Memorandum

Subject: Resolution No. R-967-19: Report Analyzing Potential Impacts to Miami International Airport from Proposed Development on the International Links Melreese Country Club - Directive No. 192075

EXHIBIT A

Airspace and Land Use Impacts from Proposed Miami Freedom Park Development

Figure 11 – Proposed Miami Freedom Park's Practice Fields Lighting and Glare Impacts⁸

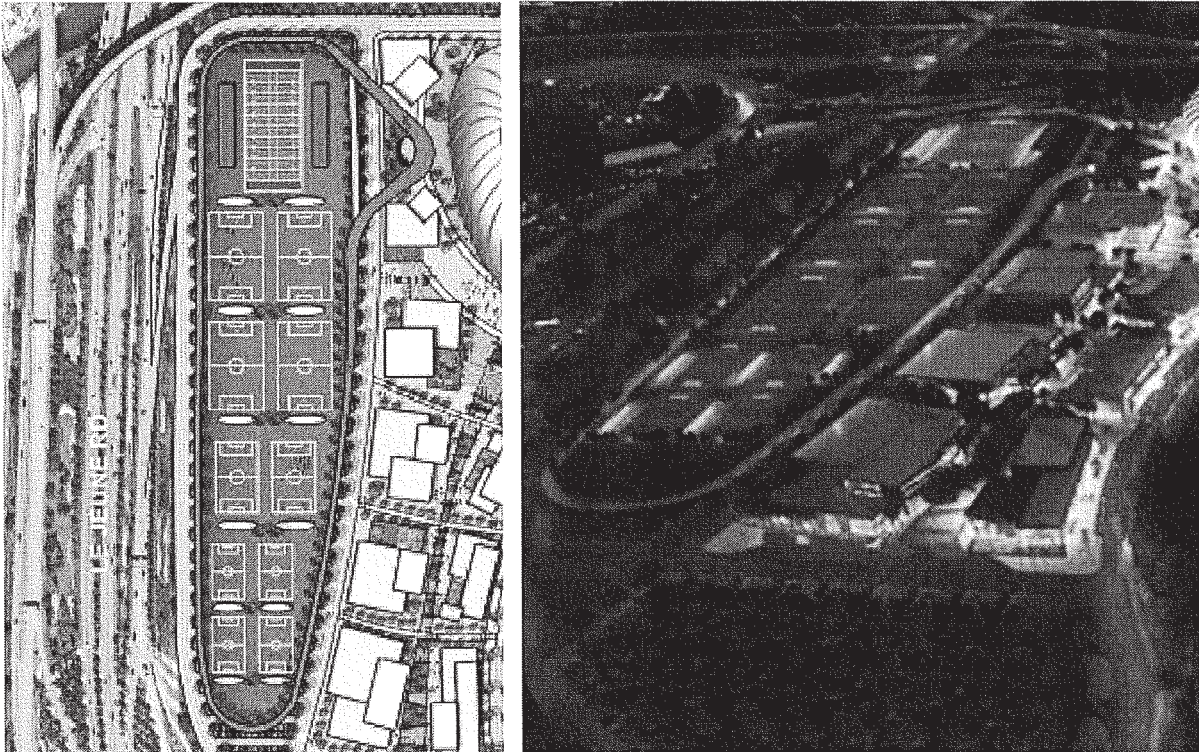
Figure 10 includes a few samples of the artistic renderings that are depicted on the Miami Freedom Park website. These renderings highlight MDAD's concerns with the lighting and glare impacts associated with the proposed soccer stadium, practice fields, and other ancillary facilities. **Figure 11** illustrates the soccer and football practice fields oriented in a north to south configuration along NW 42nd Avenue, which are expected to include field lighting. These lights will create an array of lights perpendicular to the approach and departure path of Runway 9-27.
